**ZONING AMENDMENT
PLANNED UNIT DEVELOPMENT &
SUBDIVISION STAFF REPORT**

Date: June 19, 2003

<u>NAME</u>	Jane Conkin
<u>DEVELOPMENT NAME</u>	The Townhomes of Batre Lane Subdivision
<u>LOCATION</u>	West side of Batre Lane, extending from the North side of Old Shell Road to the South side of Gaillard Street
<u>PRESENT ZONING</u>	R-1, Single-Family Residential
<u>PROPOSED ZONING</u>	R-3, Multi-Family Residential
<u>AREA OF PROPERTY</u>	1 Lot / .9± Acres
<u>CONTEMPLATED USE</u>	Three, two-unit townhomes on one lot, with shared parking and access It should be noted, however, that any use permitted in the proposed district would be allowed at this location if the zoning is changed. Furthermore, the Planning Commission may consider zoning classifications other than that sought by the applicant for this property.
<u>TIME SCHEDULE FOR DEVELOPMENT</u>	Immediately
<u>ENGINEERING COMMENTS</u>	Must comply with all stormwater and flood control ordinances. Any work performed in the right of way will require a right of way permit.

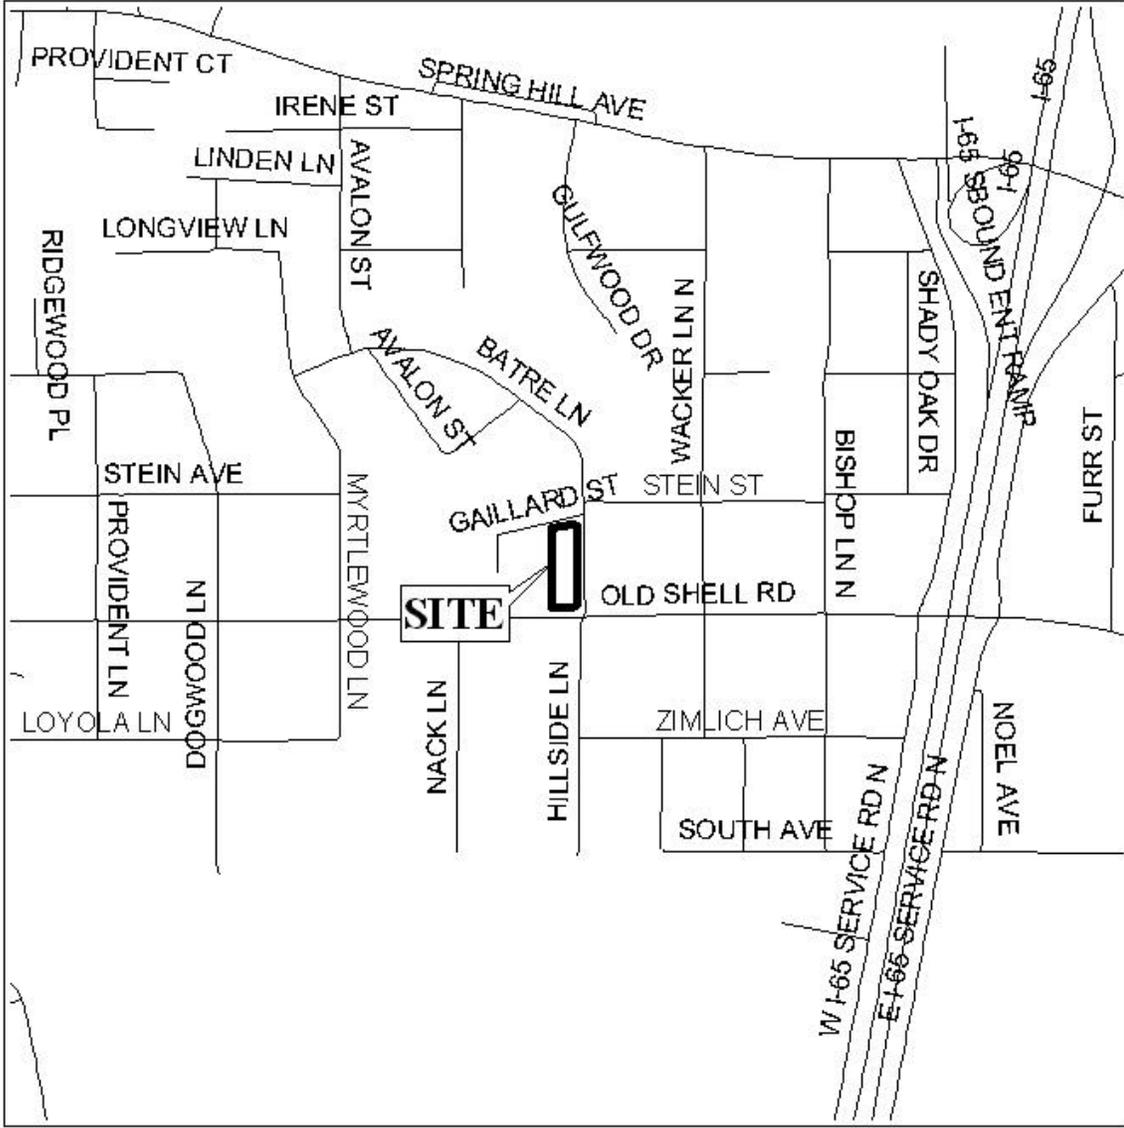
As illustrated on the site plan, the six units and guest parking would access Gaillard Street. Gaillard Street is a minor residential street with substandard improvements—the pavement is only 16-feet wide, less than the standard driveway width for two-way traffic in a parking lot. Gaillard Street also serves as the only access for six existing homes to the West, and the approval of six dwelling units on this site would essentially double traffic on the substandard street.

The applicant is also requesting a reduced front setback of 15-feet. Although reduced front setback requests are frequently granted, the reduced setback is typically within a homogenous development, not on a single block within an existing neighborhood.

Regarding the Subdivision request, as the topography of the site makes a curb cut to Batre Lane difficult, and as the site previously accessed Gaillard Street, the site should be restricted to one curb cut to Gaillard Street

Subdivision: Based upon the preceding, this application is recommended for approval subject to the following condition: 1) that the site be limited to one curb cut to Gaillard Street.

PLANNING COMMISSION VICINITY MAP - EXISTING ZONING

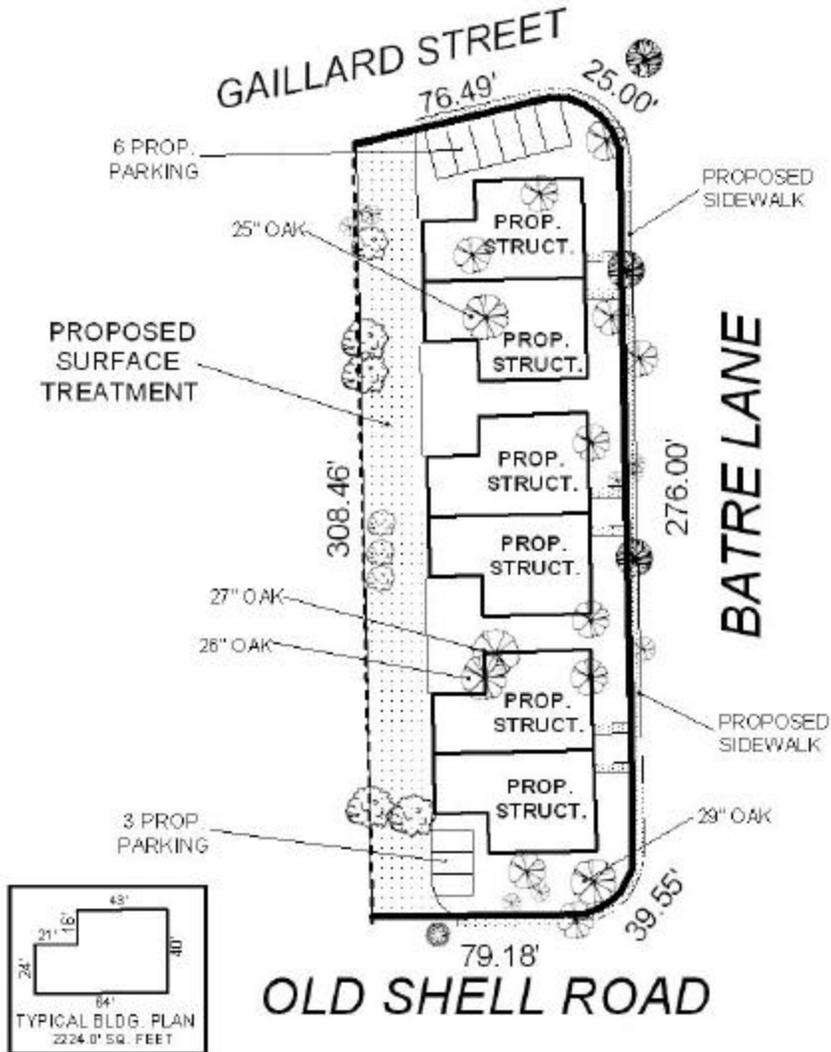
As illustrated on Vicinity Map there is no R-3 zoning in the immediate area and at less than one acre, the site falls well below the minimum recommended guideline of four acres for the creation of a free-standing R-3 district. As such, the rezoning of this site could be considered spot zoning.
